ROBINSON
36 CATHEDRAL DRIVE, SPALDING.
REVISED ELEVATIONS 1:100 / 31.7.02 / MD.

PROPOSED EXTENSIONS AND ALTERATIONS TO EXISTING BUNGALOW AT:
36 CATHEDRAL DRIVE, SPALDING, LINCOLNSHIRE.

FLOOR PLAN & ELEVATIONS AS PROPOSED.

DATE MAR 02 | DRAWING No. 02.004/01

ROBINSON
36 CATHEDRAL DRIVE, SPALDING
REVISED PLAN.
1:50 /31.7.02/ MD.

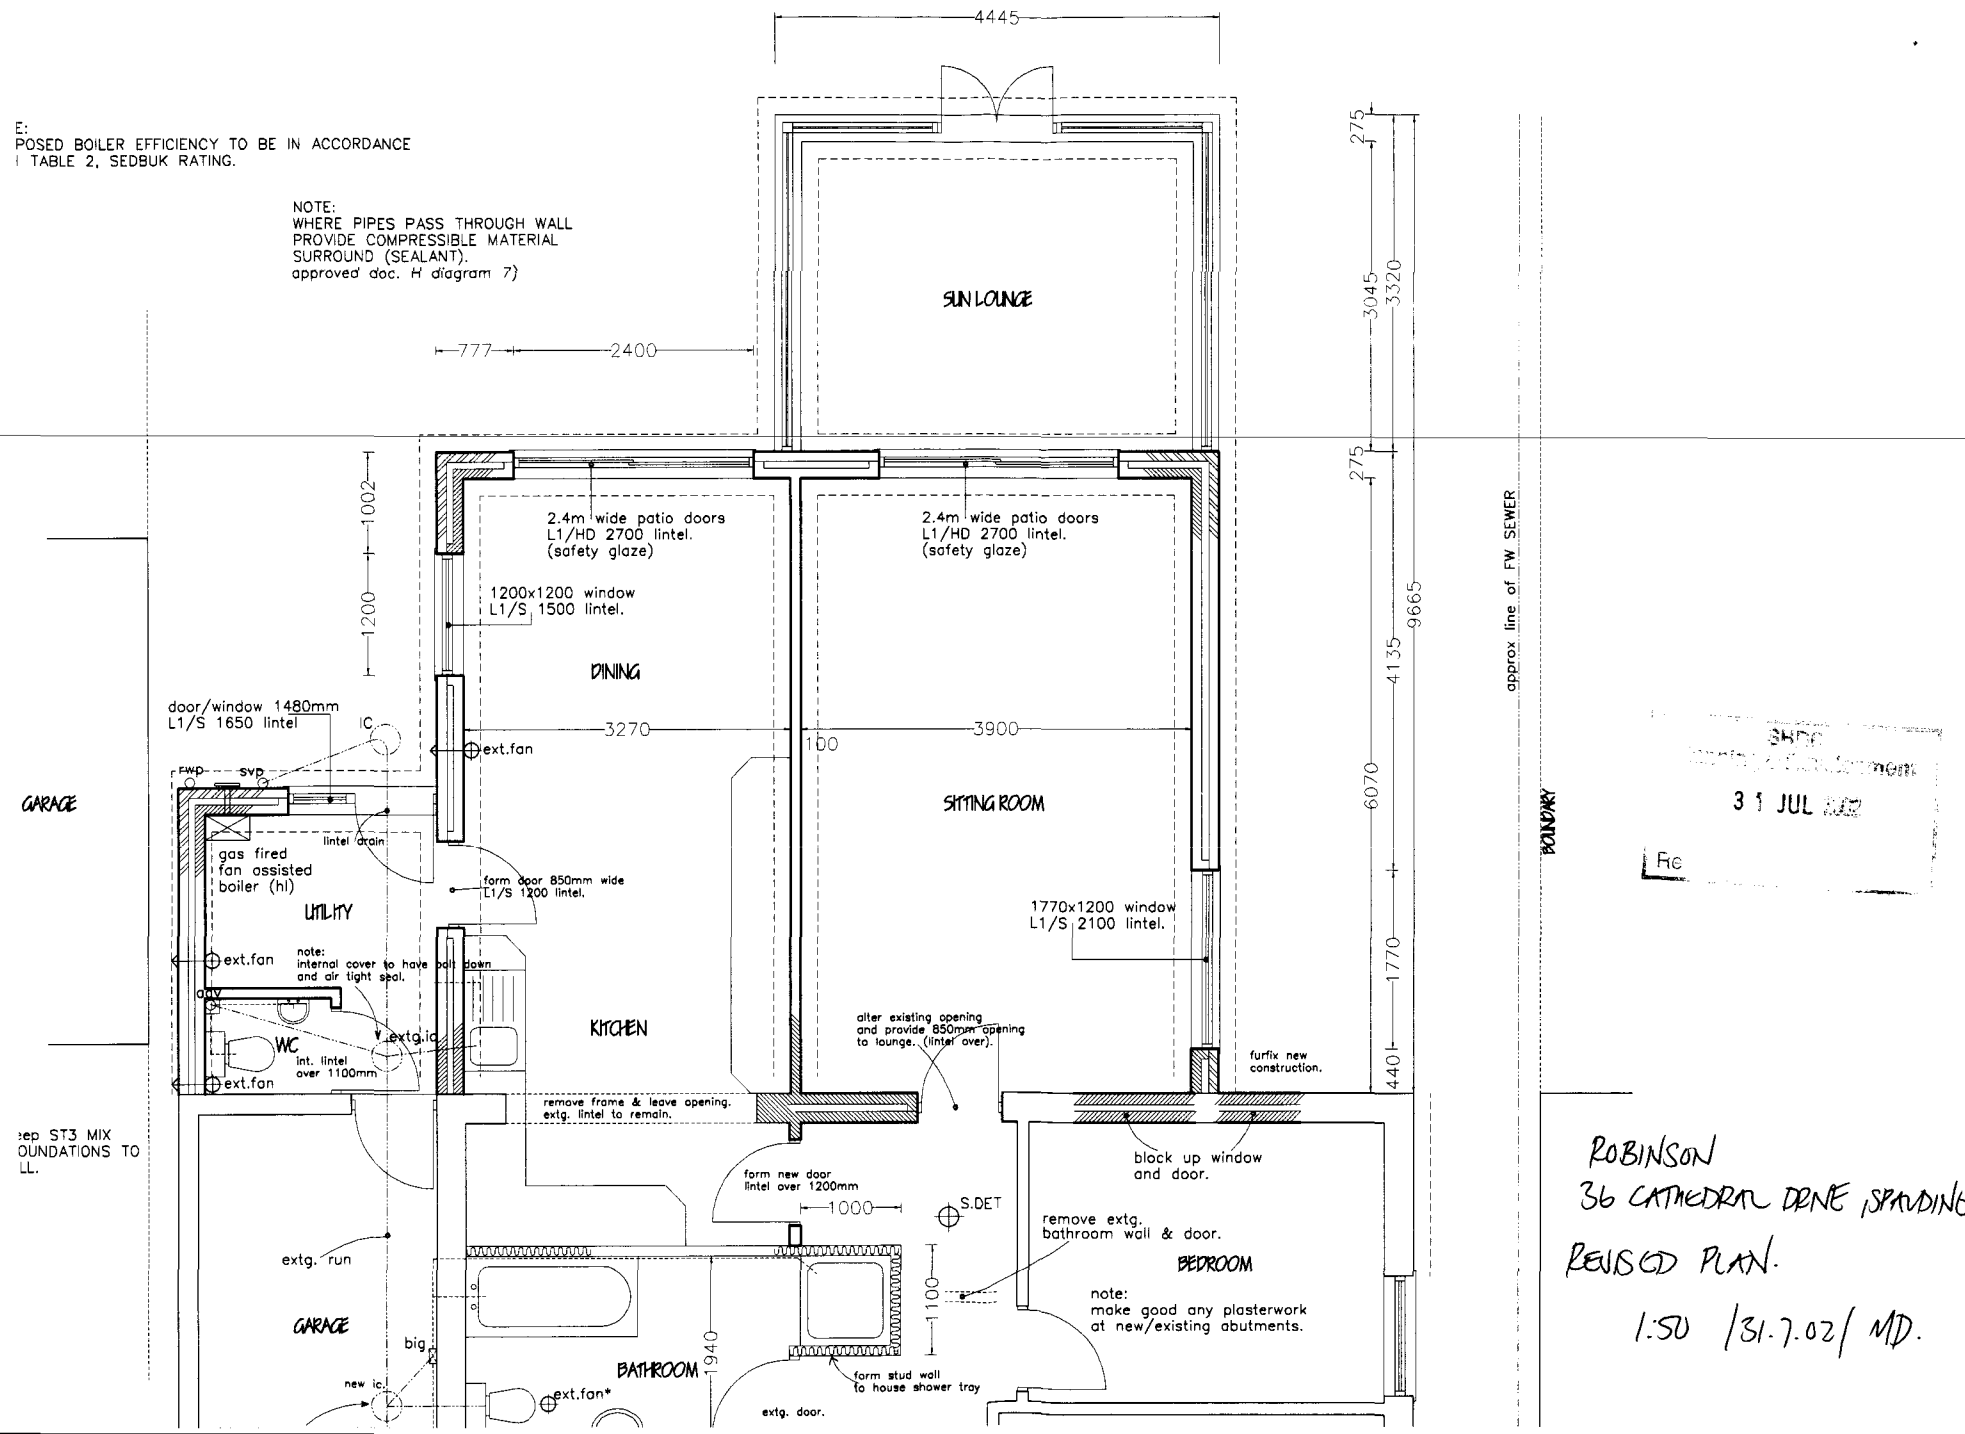
E:
POSED BOILER EFFICIENCY TO BE IN ACCORDANCE
TABLE 2, SEDBUK RATING.

NOTE:
WHERE PIPES PASS THROUGH WALL
PROVIDE COMPRESSIBLE MATERIAL
SURROUND (SEALANT).
approved doc. H diagram 7)

ep ST3 MIX
OUNDATIONS TO
LL.
